Project	IEEE 802.16 Broadband Wireless Access Working Group http://ieee802.org/16 Corrections on MS network entry procedures in transparent RS systems 2007-07-15	
Title		
Date Submitted		
Source(s)	Kanchei (Ken) Loa, Yi-Hsueh Tsai, Yung-Ting Lee, Hua-Chiang Yin, Shiann-Tsong Sheu, Youn-Tai Lee,	Voice: +886-2-27399616 Fax: +886-2-23782328 loa@nmi.iii.org.tw
	Institute for Information Industry 8F, No. 218, Sec. 2, Dunhua S. Rd., Taipei City 106, Taiwan	
	Masato Okuda	okuda@jp.fujitsu.com
	Fujitsu	
Re:	IEEE 802.16j-07/019: "Call for Technical Comments Regarding IEEE Project 802.16j"	
Abstract	This contribution proposes corrections on MS network entry procedures in transparent RS systems.	
Purpose	Text proposal for 802.16j Baseline Document.	
Notice	This document does not represent the agreed views of the IEEE 802.16 Working Group or any of its subgroups. It represents only the views of the participants listed in the "Source(s)" field above. It is offered as a basis for discussion. It is not binding on the contributor(s), who reserve(s) the right to add, amend or withdraw material contained herein.

Correction on MS network entry procedures in transparent RS systems

This contribution

Table 199a—Ranging and automatic adjustments procedure in MRtransparent mode

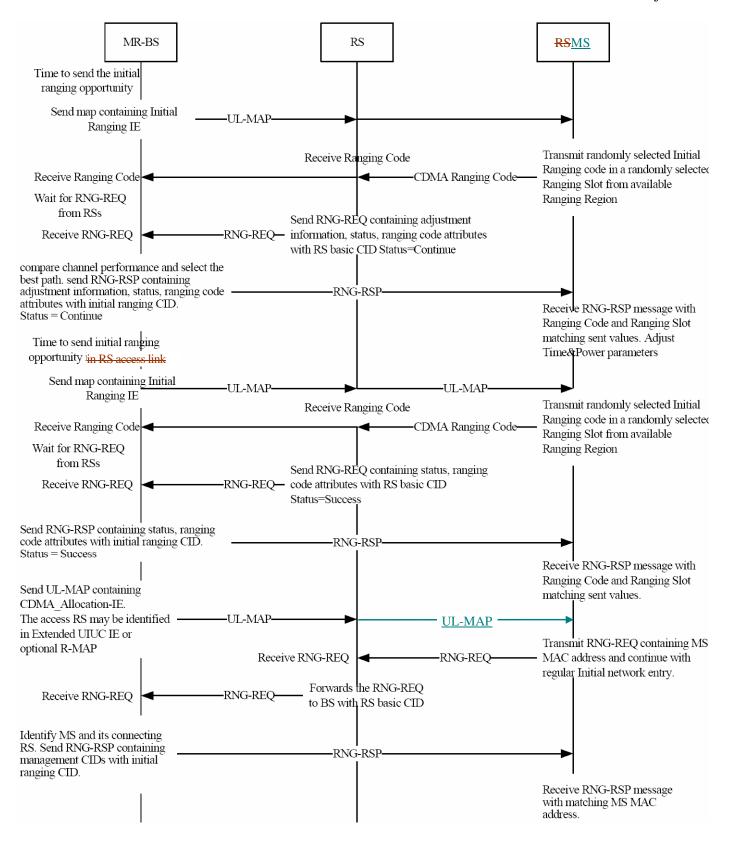
[Change the figure 199a in page 79 as indicated]

Figure 95a—Handle CDMA initial ranging code at transparent RS

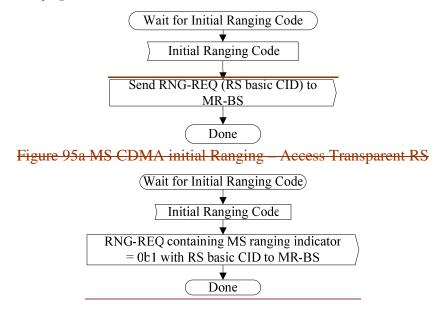
[Replaced the figure 95a in page 80 as indicated]

Figure 95b—Handle RNG-REQ in transparent RS

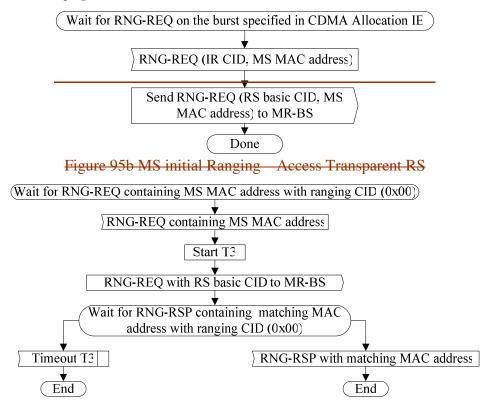
[Replaced the figure 95b in page 80 as indicated]

Figure 95c—Handle CDMA initial ranging code in transparent mode at MR-BS

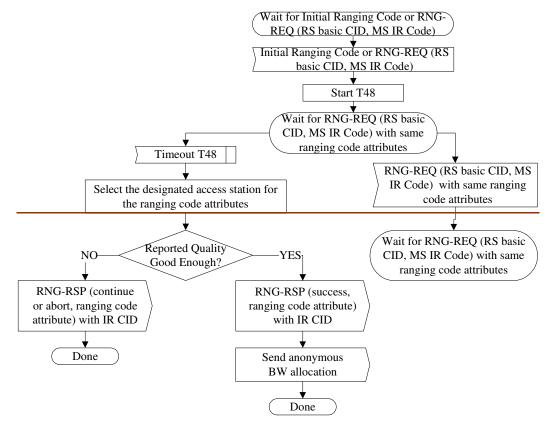
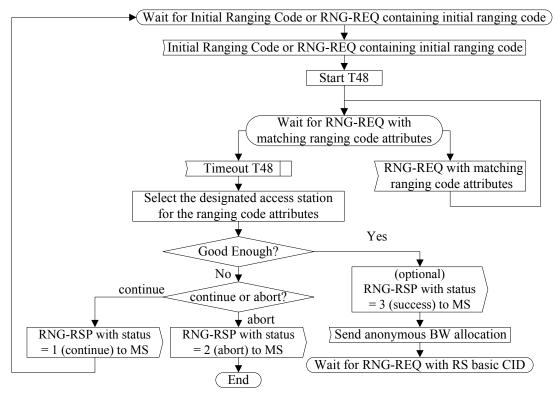
[Replaced the figure 95c in page 81 as indicated]

Figure 95d—Handle RNG-REQ in transparent mode at MR-BS

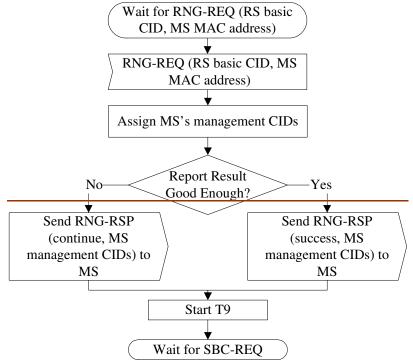
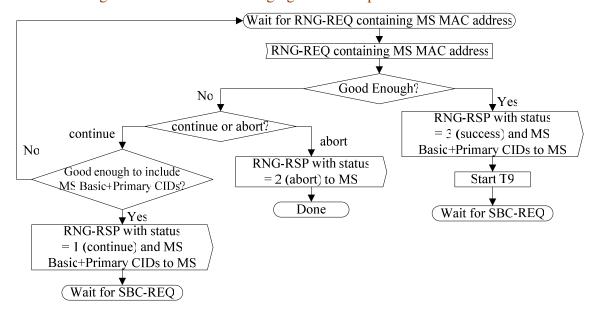
[Replaced the figure 95d in page 82 as indicated]

Note: T9 is the timer between the MR-BS sending an RNG-RSP to an MS and receiving an SBC-REQ from the same MS
